RE: PETITION FOR SPECIAL EXCEPTION : BEFORE THE ZONING COMMISSIONER
PETITION FOR VARIANCE
N/S of Bellona Ave., 74.39' W of: OF BALTIMORE COUNTY
Lutherville Rd. (1312 Bellona Ave.), 8th District

SUBJECT: Zoning Petition No. 87-244-XA

PROJECT NAME: 1312 Bellona Avenue

PETITIONER:
PLAT TO ACCOMPANY A PETITION FOR A SPECIAL EXCEPTION FOR A CLASS 'B' OFFICE BUILDING AND VARIANCE
1312 BELLOVA AVENUE
BALTIMORE COUNTY

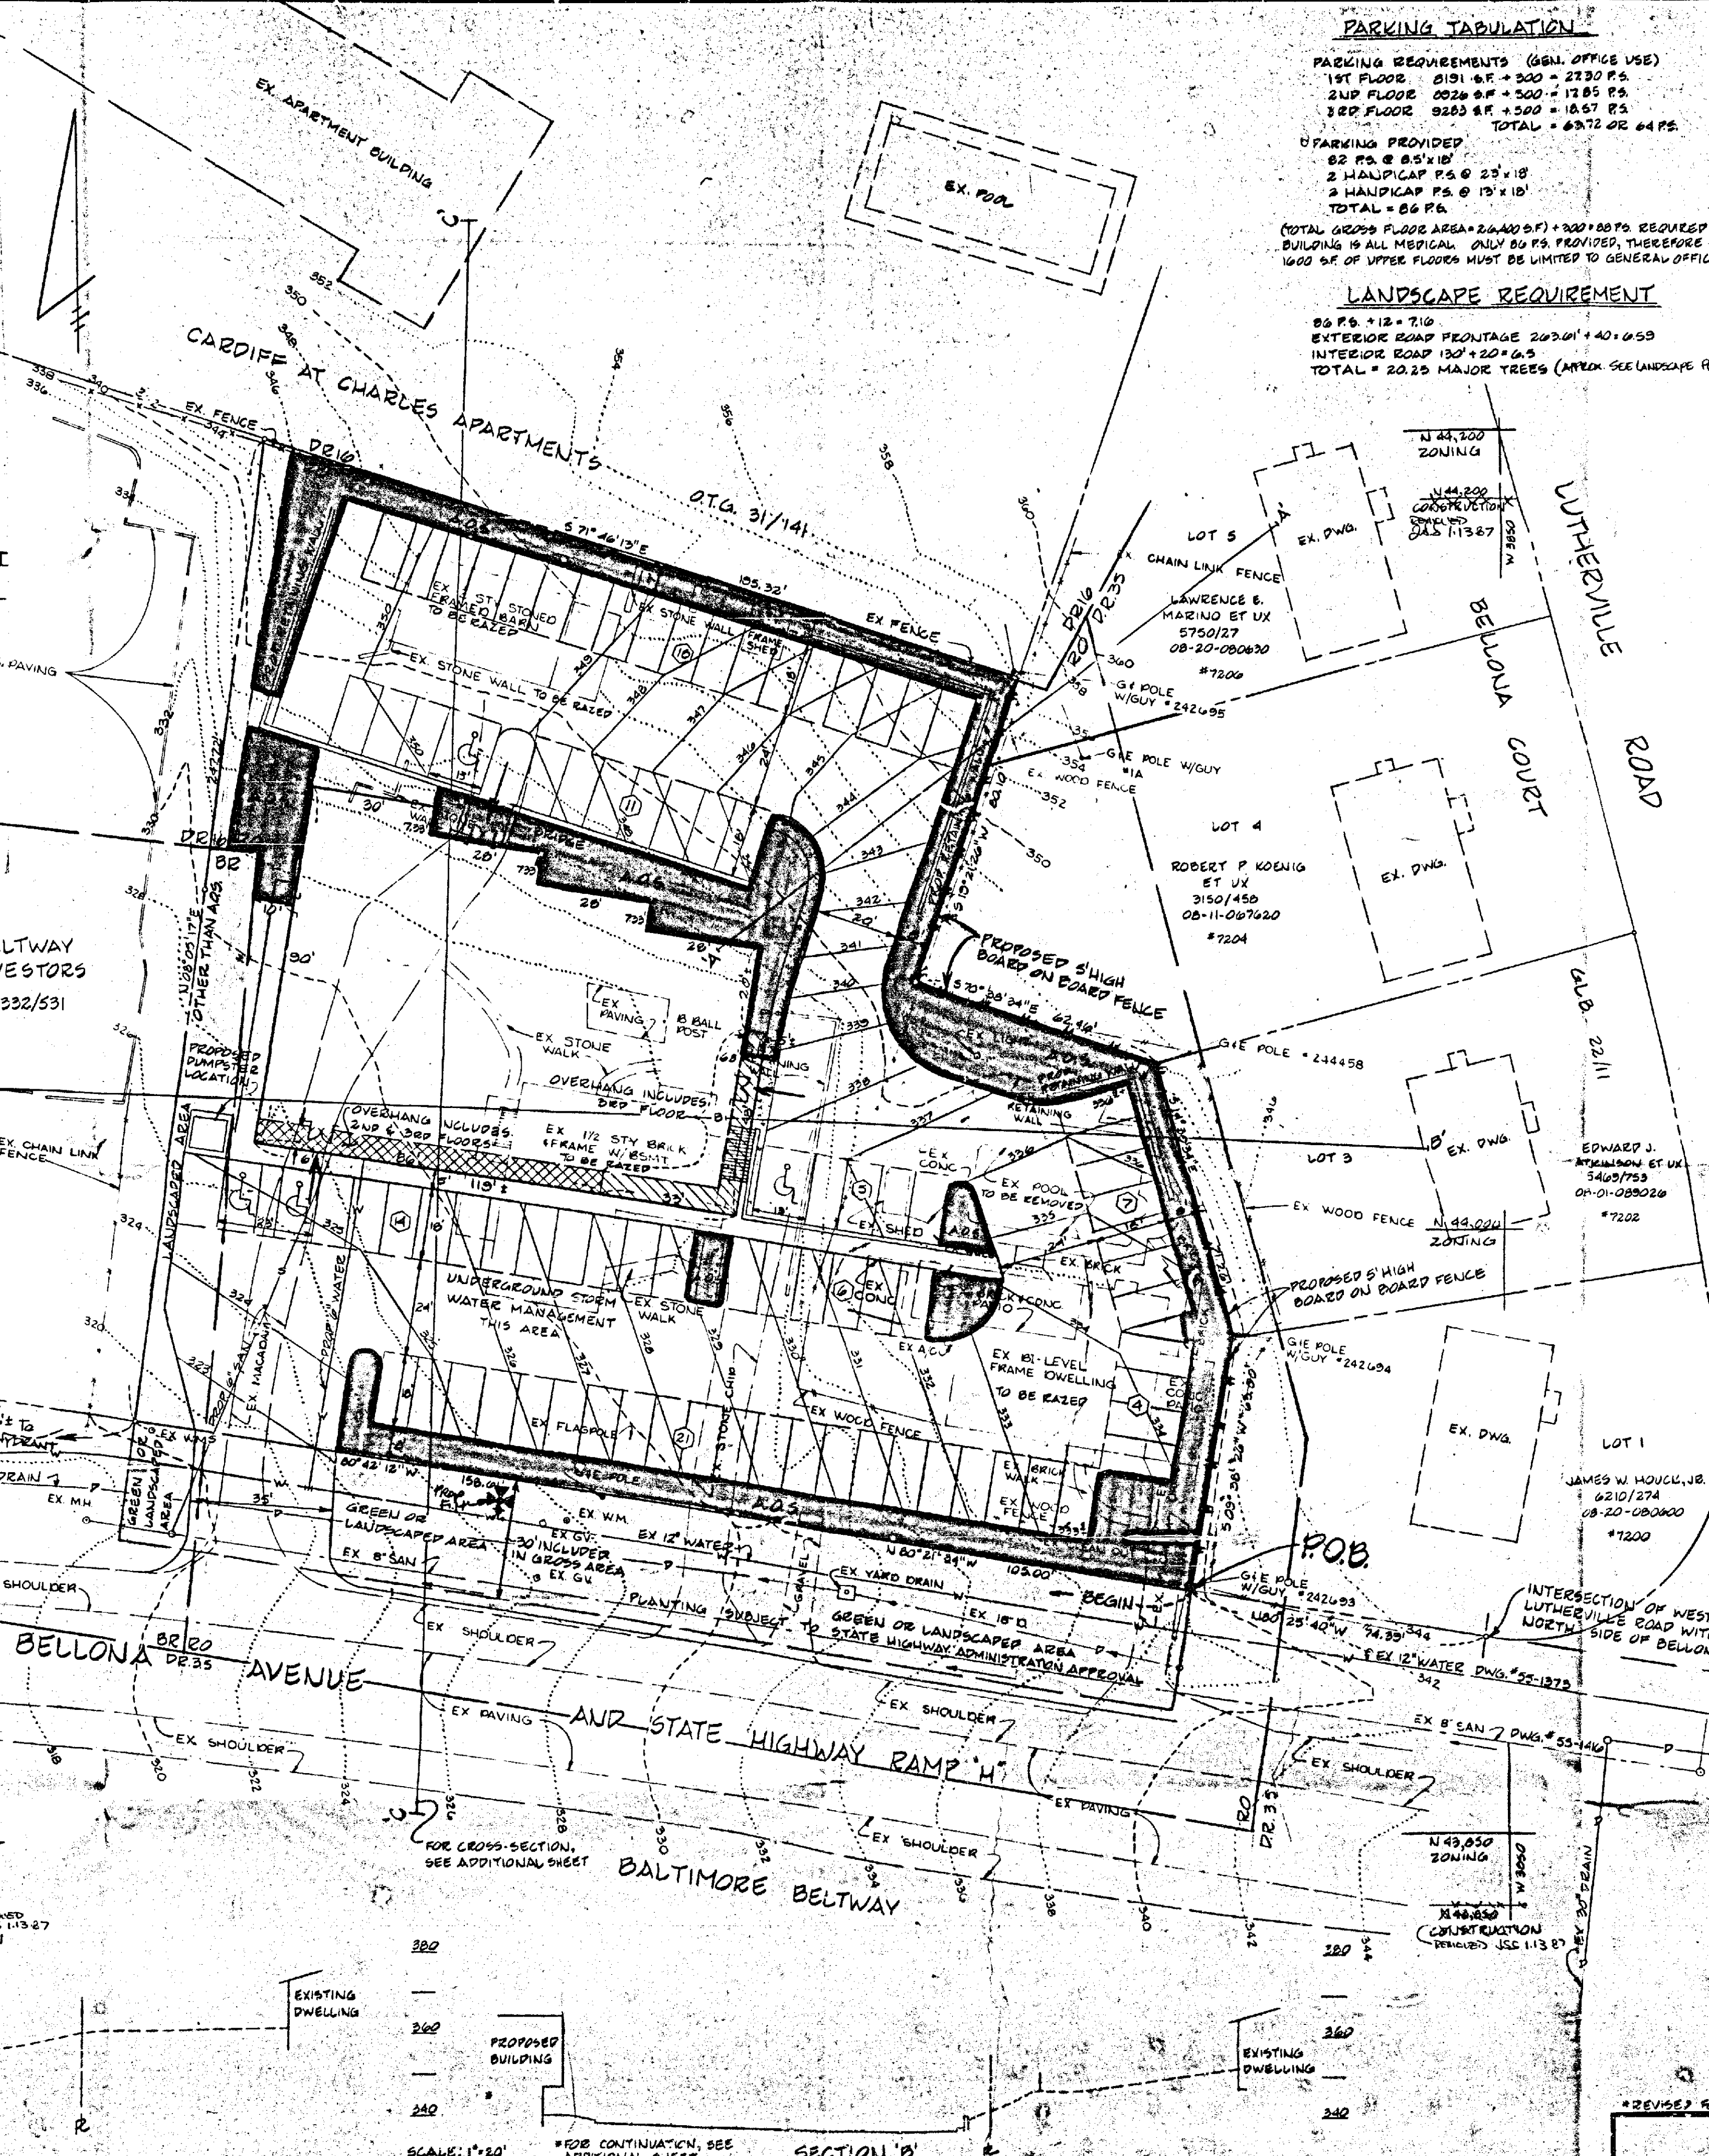
2) Please update the Zoning hearing plans and especially the revised zone line on this plan as shown corrected by this office. Both zone lines should be shown due to the inconsistency as the two official maps are placed together. The zone line issue should be addressed at the hearing because it affects other factors on the site plan.

3) A sign variance has not been requested, so Note #20 should be revised.

On review of the submittal of 9/23/86 and field inspection, the State Highway Administration Bureau of Engineering Access Permits will require the site plan to be revised.

The revised site plan must show all access to the site by way of a standard 35' entrance with 10' radii, located at the west property line.
